**CALIFORNIA COASTAL COMMISSION**

## STAFF REPORT: APPEAL – DE NOVO

**Application No.:** A-5-LGB-16-0098

**Project Description:** Exterior & interior alterations/renovations and addition to a 2,585 sq. ft. two-level single-family residence with an attached garage on an ocean-fronting bluff. Project work includes an approximately 1,603 sq. ft. net addition of gross floor area, conversion of 107 sq. ft. of floor area into garage space, 227 sq. ft. mechanical space additions, net new 264-sq. ft. addition of deck area, removal of wood stairs on the bluff face, interior renovations and modifications, 425 cu. yds. of grading, and new landscaping.

Figure 1: Local stability of the upper bluff (bedrock contact and above) - Critical Factor of Safety (FoS) of 1.45 and 1.50 for static conditions (Note: Blue arrows indicate location of residence; Red lines demarcate the 1.45 (left) and 1.50 (right) FoS lines)

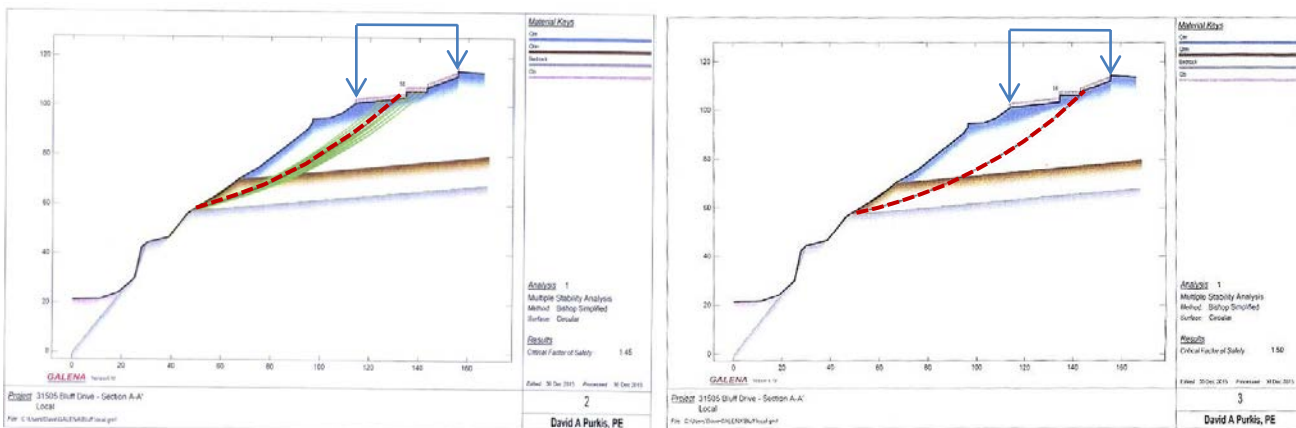
While the FoS for static conditions preliminarily appears to meet the LCP’s minimum requirement of 1.5, an assessment of where the FoS lines are located on the bluff relative to the location of the residence and the proposed development is also necessary because Action 10.2.6 requires that the *development* maintain the required factor of safety. Based on the location that the local FoS lines appear on the bluff face, and based on the existing residence in relation to those FoS lines, the existing residence is not completely sited in a location that assures geologic stability.

Figure 1 above depicts that the factor of safety lines of 1.45 and 1.50 for static conditions daylight (appear on the bluff face) under the existing residence. This is likely due to the fact that the coastal bluff surficially consists of poorly-consolidated marine and non-marine terrace deposits, even though the subject site is underlain by conglomerate bedrock known as San Onofre Breccia, which is a highly stable geologic formation. In addition to landslide potential, the bluff is also subject to erosion and retreat over time. As the bluff retreats, the factors of safety of the project site are also expected to decrease. Therefore, the project site seaward of the 1.5 FoS lines are not suitable for the new development (including additions). The portions of the existing residence and associated structures seaward of the minimum factors of safety will likely be threatened by erosion within the next 75 years.
